North Hertfordshire District Council

Building Conservation comments

File Ref: 24/02117/FPH

Subject: Single storey rear extension and alterations to fenestration. Erection of rear outbuilding to facilitate golf simulator/gym/office with associated decking; erection of greenhouse/store following demolition of existing outbuilding. Installation of front entrance gate to driveway.

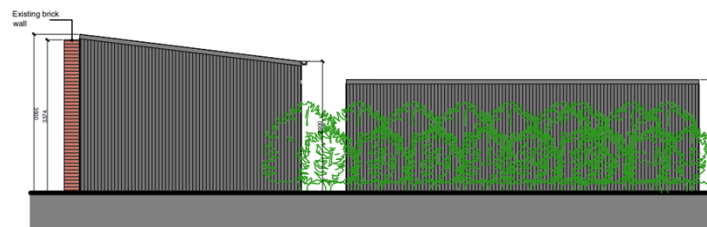
- 5.3 Not only would there be more buildings within the walled garden their form and the materials used does not infer that these are garden buildings. Although the amount of glazing is less than the existing buildings, the large, glazed sliding doors are the most significant element, in particular, the more horizontal than vertical form of glazing serving the golf simulator section. Even the images shared at page 18 of the DHS are considered to have better proportions.

I encourage a slight reduction in the width of the glazing to the Wellness and Home Office section and would not be opposed to a splayed section being introduced either side as noted in the left-hand image above. However, at my site meeting on 13/01/2025 the applicant was not amenable to this suggestion. I also suggested adjusting the size of the larger opening also to match that of the Wellness and Home Office section even if this then required

a single much narrower glazed panel in front of the cycling machine? This was also not received positively. However, the applicant is prepared to consider a reduction in the width of the glazed opening, and this is to be encouraged. More vertical door proportions are to be encouraged. Furthermore, and something I did not raise on site, is whether it would be appropriate to introduce a timber external door to the lobby? In short, I am not entirely convinced by the current approach in the image below

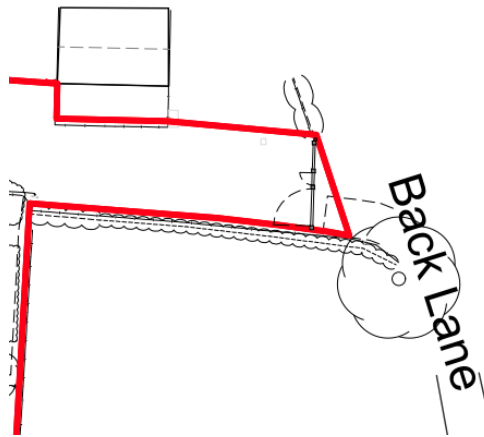
- 5.6 Furthermore, the greenhouse / potting shed did not form part of the pre-application and introducing a further, yet smaller building in the same style as the main building will only serve to reinforce this build-type. This is an important consideration in that the rear of this building is more ‘exposed’ as there is no wall on this side of the quadrant. From Back Lane there are glimpse views afforded across to Manor Farm and to the remains of the Church of St. Etheldreda. Although there is a case to suggest that the greenhouse and store as opposed would have limited impact upon the setting of both, it is still considered that a contrasting and more traditional build type being proposed for the greenhouse / potting shed so that this building at least had more of a wall garden aesthetic.

- 5.7 I would not be opposed to a building similar to that in the images below and the applicant appeared to be amenable to this suggestion at my site meeting on 13/01/2025.
